COUNCIL ASSESSMENT REPORT

Panel Reference	2017SCL037 DA
DA Number	DA-2017/371
LGA	Bayside
Proposed Development	Construction of a part two and three storey residential flat building comprising 10 residential units fronting New Illawarra Road and a second residential flat building of up to 5 storeys in height and comprising 14 residential units fronting Bexley Road including parking underneath.
Street Address	84 New Illawarra Road (and former 313 Bexley Road), Bexley North
Applicant/Owner	NSW Land and Housing Corporation
Date of DA Lodgement	9 June 2017
Number of Submissions	Submissions for 60 different parties, all in opposition, with one later becoming a letter of support.
Recommendation	Approval, subject to design amendment conditions
Regional Development Criteria (Schedule 7 of the SEPP (State and Regional Development) 2011	CIV > \$5M - Crown Development CIV > \$5M – Affordable Housing Development
List of all relevant s4.15(1)(a) matters	<p>State Environmental Planning Policy (State and Regional Development) 2011</p> <p>State Environmental Planning Policy (Building Sustainability Index: BASIX) 2004</p> <p>State Environmental Planning Policy (Infrastructure) 2007</p> <p>State Env

Figure 3 Section A-A showing natural ground line in relation to the basement and ground floor levels
(Source: Land and Housing Corporation, 2018)

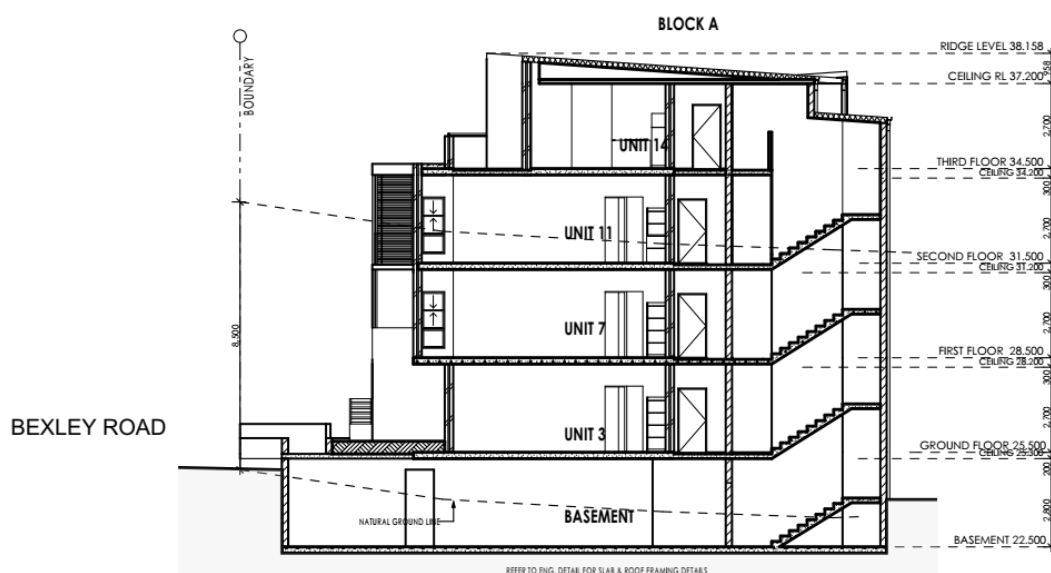
Section A-A (roughly through the centre of the building) shows that the ground floor of Block A adjacent to Bexley Road is approximately 0.9m above natural ground. This plan also shows that the ground floor towards the rear is as much as 2m above natural ground. The section plan below, drawn through the centre of the building, provides a graphic comparison between the natural ground level and the floor levels of the building.

This would indicate that additional storeys are proposed beyond that accounted for within the Site Compatibility Certificate, particularly towards the centre of the site. LAHC provided a response to Council in relation to this issue, which claimed that references to storeys within the SCC was a reference only to habitable floors.

Figure 4 North elevation showing the maximum extent of the basement protrusion above natural ground visible within toward the bottom right of the image (note that the markings on the plan relate to a design amendment and not to the basement protrusion).

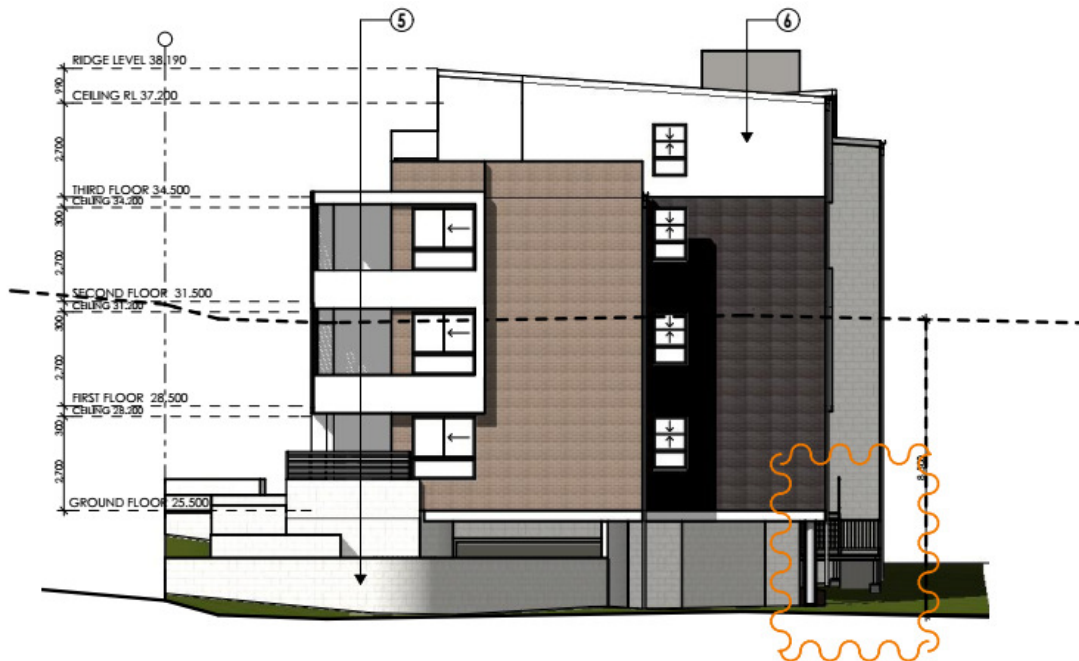
The northern part of the site is lower than the southern side and therefore at the northern end of the building, the ground floor sits higher relative to the natural ground level. It is estimated that the ground floor at the northern end of the building may be as much as 2.7m above natural ground, and the extent of the natural ground level variation, in relation to the proposed building, can be understood from the image below.

Figure 9 Midwinter shadow diagrams – 1pm (subject to design amendment)
(Source: Land and Housing Corporation, 2019)

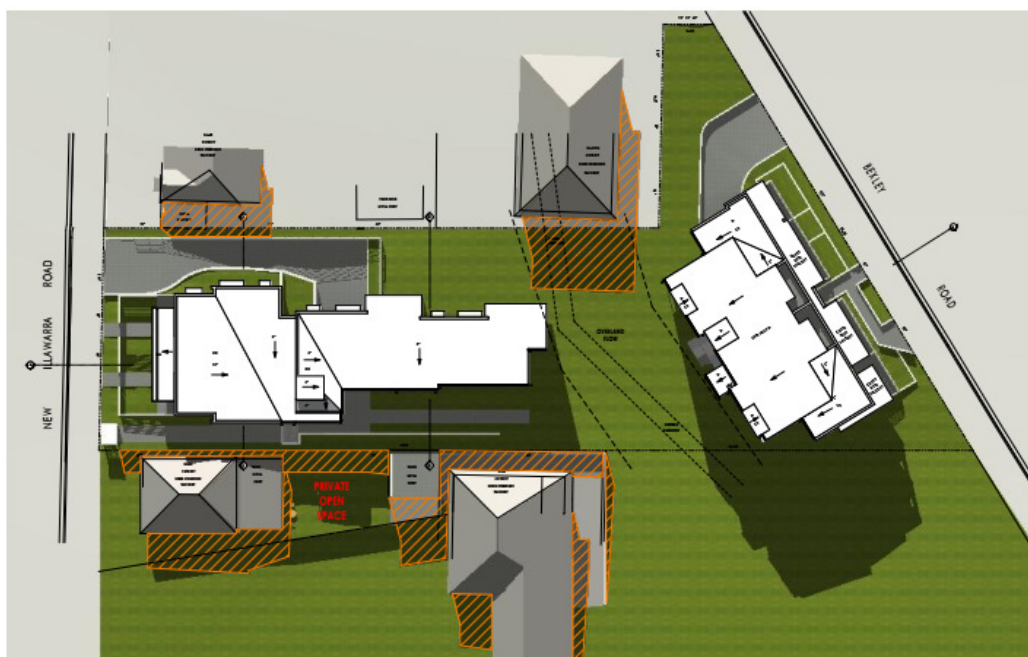
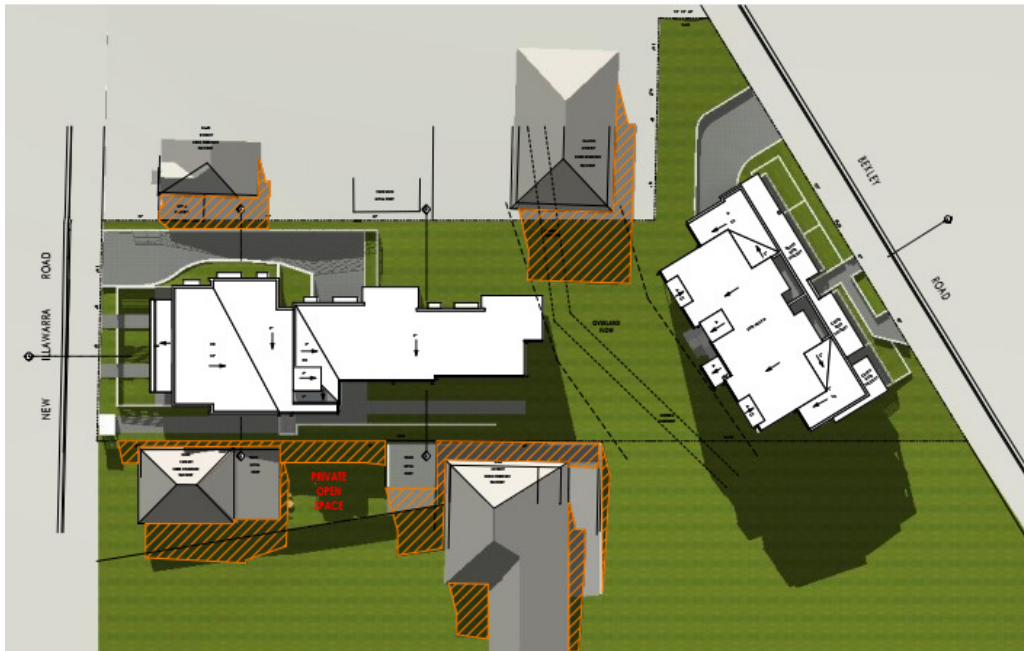
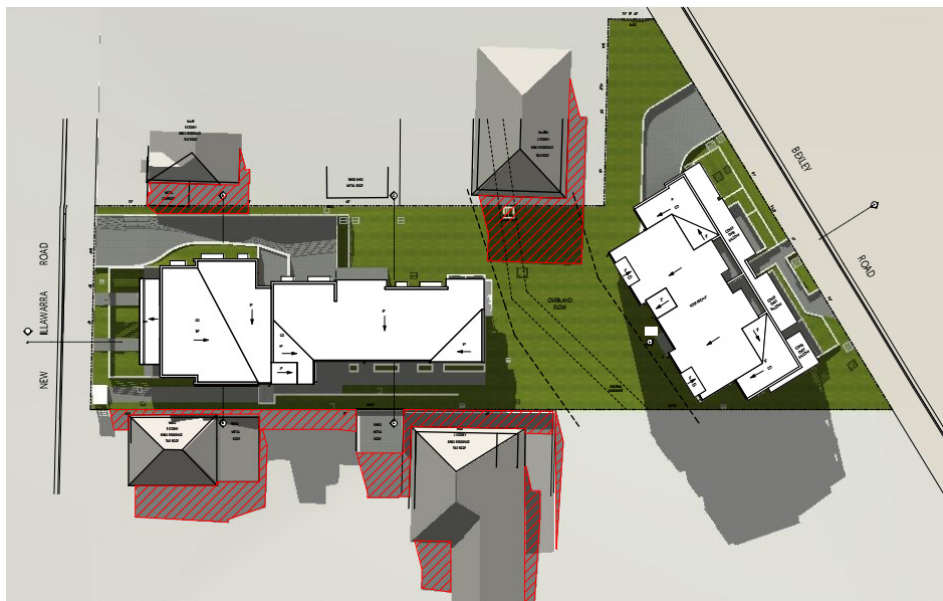
In response, the vertical circulation areas were relocated further to the north and the relative location of the lift and stairs were reversed, resulting in the taller element, the lift overrun, being located to the north of the stairs. However, each of these elements are still currently proposed on the southern half of the property and still cast the longest shadows into the private open space of No.82 New Illawarra Road.

The applicant has submitted to Council that a reduction in the height of the lift overrun by 0.6m, would largely negate the *extra* shadow cast by the lift overrun, beyond that cast by the stairs. Amended shadow diagrams were submitted seeking to demonstrate this to be the case (although no plan amendment was submitted).

The additional shadows cast by the lift overrun and adjacent roof element can be seen within the centre of the rear yard of No.82 New Illawarra Road as shown within Figure 9 above. For comparison the following images show the shadows cast by the current design (Figure 10), and those cast by the preceding design (Figure 11).

they would agree to a design amendment condition to lower the lift overrun by 0.6m, and such a condition is included within the draft conditions. It should also be noted that Council has in the past permitted variations to numerical controls, typically the height development standard, where the non-compliant portion was generally limited to the lift overrun or rooftop plant, etc. This highlights that it is typically Council practice offer leniency towards lift overruns, etc, when assessed against height limits (in this case, the building height limit set by the SCC).

Figure 12 Midwinter shadow diagrams – 10am (subject to design amendment)
(Source: Land and Housing Corporation, 2019)

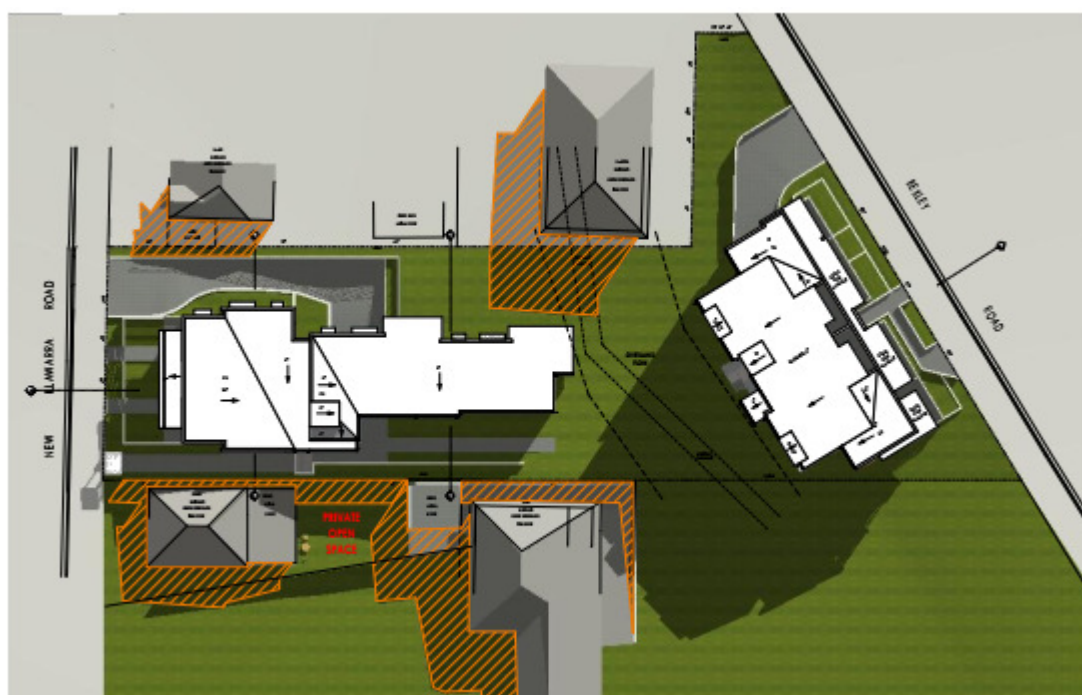
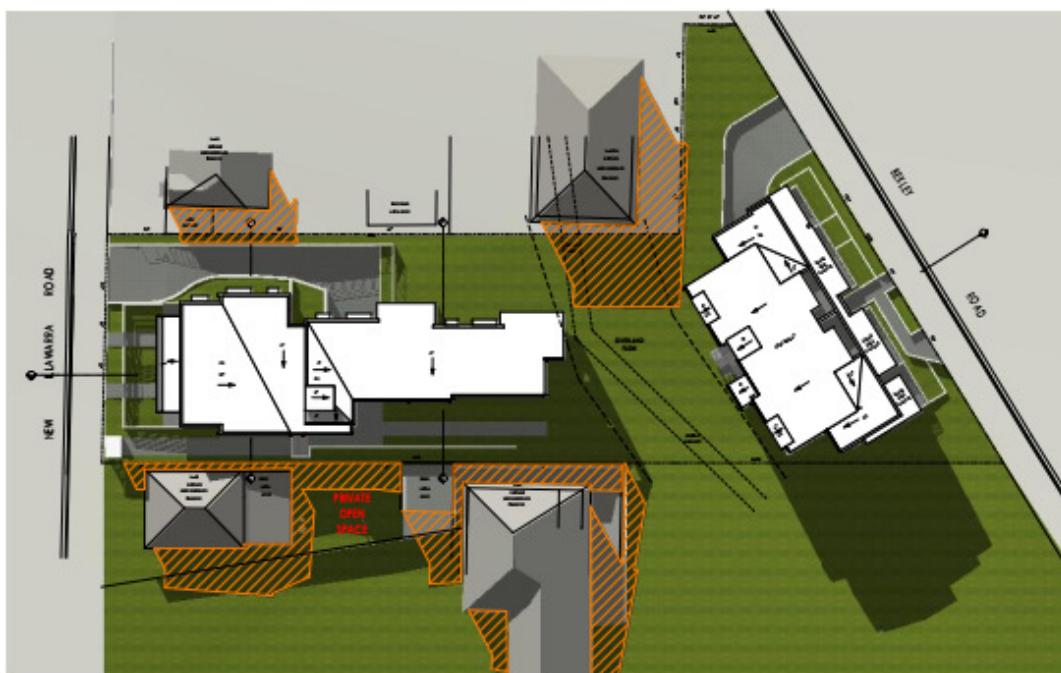
Moreover, Block A is oriented to align with Bexley Road, ensuring that the parts of the building that are closest to the boundary are limited to “corners” of the building. In addition, the building has a relatively slender design, allowing the shadows to move across the park relatively quickly during the winter solstice.

These shadow diagrams show that the only portion of the park which would be overshadowed continuously from 10am to 2pm is concentrated near the boundary, directly to the south of the building, representing a very small portion of the park. Aside from overshadowing from the retaining wall to the property at No.3 Barnsbury Grove, the park is otherwise provided with excellent solar access, particularly as the park widens towards the south. The approach to this aspect of the design is considered acceptable and the level of overshadowing to the park is satisfactory. It should be noted that these conclusions regarding overshadowing to Whitbread Park would be the same irrespective of whether the development were approved as is proposed, or whether the development were approved with the recommended design amendment condition to delete the top storey to Block A,
